July 19, 2006

SUBJECT: EXEMPTION FROM 10 CFR 72.48, 10 CFR 72.212 AND 72.214 FOR DRY
SPENT FUEL STORAGE ACTIVITIES - FORT CALHOUN (TAC NO. L23984)

SAFETY EVALUATION REPORT
EXEMPTION FOR
OMAHA PUBLIC POWER DISTRICT
FORT CALHOUN STATION
INDEPENDENT SPENT FUEL STORAGE INSTALLATION
DOCKET NO. 72-54

Figure 1 - Supplemental Shielding in Decontamination Area

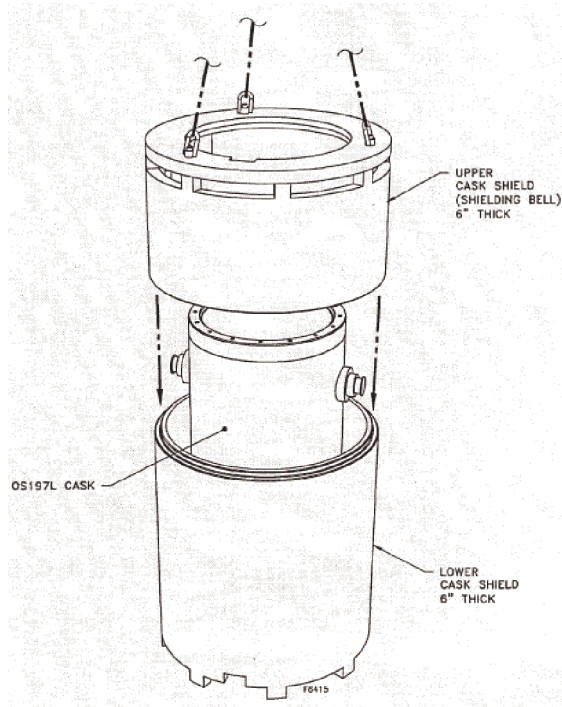
The supplemental shielding used in the decontamination area and on the transfer trailer is not part of the OS197L TC. Therefore, the staff does not agree with the applicant's assertion at the bottom of page 14 of Attachment 1 to the exemption request: "The radial shielding of the OS197L TC, including the decon area sleeve/bell, is documented in FCN 321, Rev. 1 [Attachment 1 of OPPD's exemption request], showing that the OS197L TC system

configuration has increased shielding.” In fact, the OS197L TC has significantly decreased shielding as compared to the OS197 TC.

Figure 2 - Supplemental Shielding on Transfer Trailer

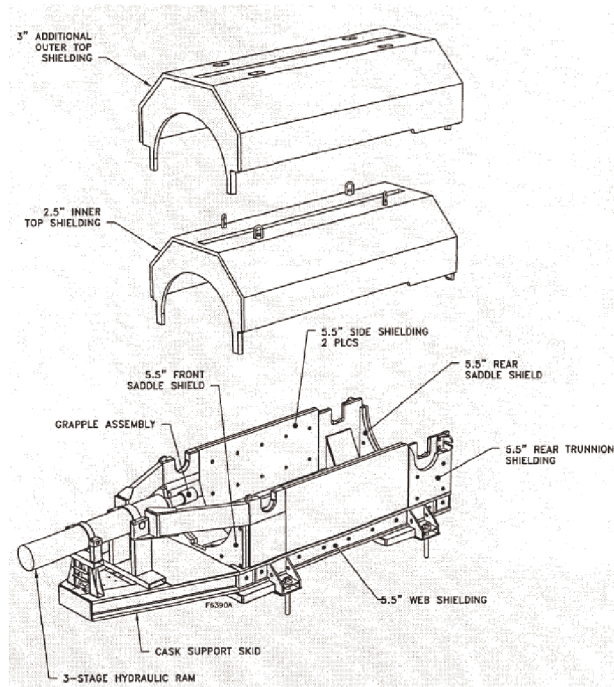
failure-proof crane, dropping of the 2.5-inch thick trailer shielding does not have to be postulated. However, the 3-inch thick outer trailer top shield is placed using a non-single failure proof crane outside of the auxiliary building. OPPD states that the lift height of the 3-inch thick shielding will be administratively limited by procedure. In the response to RAI-4, OPPD evaluates the dropping of the 3-inch thick outer top shield and concludes that if it did drop it would contact the 2.5-inch thick inner top shielding and the load would be transferred directly to the skid/trailer, and then into the four 75-ton trailer jacks. OPPD maintains that the TC would not be affected by such a drop and the dropping of the 3-inch thick shielding is bounded by the updated FSAR evaluation of an 80-inch unrestricted drop of the TC. The staff agrees that the 80-inch drop analysis bounds the dropping of the 3-inch thick trailer outer top shield and therefore, dropping of the 3-inch thick shielding does not create the possibility of a new accident that requires prior NRC approval.

Regarding the impact that the transfer trailer shielding would have on the 80-inch unrestricted drop analysis, OPPD committed to adding a discussion through a FCS specific 72.212 evaluation prior to fuel handling. This discussion would be added to section W.11.1.3 of the updated FSAR and provides reasons for why any inclusion of additional structures, such as the skid, trailer, or shielding will only reduce the drop distance and will provide additional energy absorption, thus reducing the DSC g-levels in the analyzed 80-inch unrestricted drop analysis. The staff agrees that it is appropriate to add this discussion to the updated FSAR and also agrees with the conclusion that the 80-inch unrestricted drop analysis bounds accidents involving the transfer trailer shielding. The staff concludes that the transfer trailer shielding, therefore, does not create the possibility of a new accident that requires prior NRC approval.
